Technical Service Bulletin

46 Squeal from front brakes

46 15 06 2039615/3 March 12, 2015. Supersedes Technical Service Bulletin Group 46 number 15-04 dated February 12, 2015 for reasons listed below.

Figure 1. Shims on back of front brake pads.

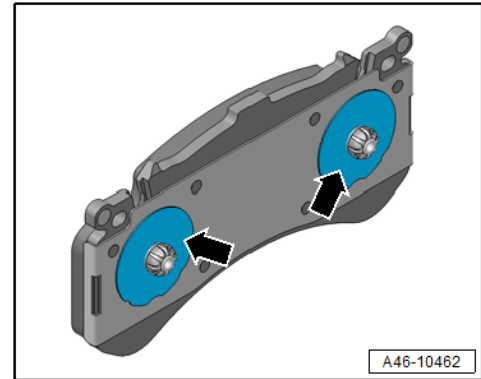
- Some vehicles may have two shims glued to the back of the front brake pads (Figure 1). **Do not** transfer these shims to the new pads.
- New brake pads have an adhesive backing that should be used to properly attach the pads to the caliper.

Figure 2. Location of pistons.

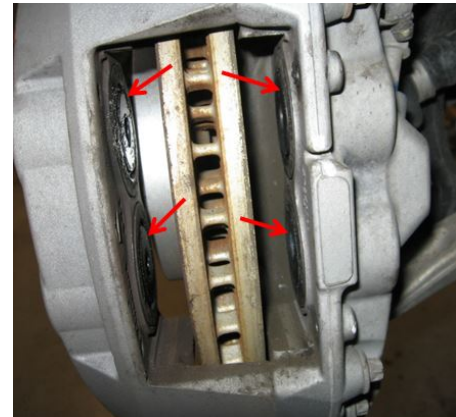
- Thoroughly clean and dry each piston (Figure 2, arrows) to ensure that the new pads will properly adhere to the pistons.
- Do not apply any lubricants to the pads or calipers.
- After the pads are installed in the calipers, apply full pedal pressure for at least 10 seconds to ensure proper adhesion of the pads to the pistons.
- In order to allow the glue to set, do not drive the vehicle for 10 minutes after new pads have been installed.
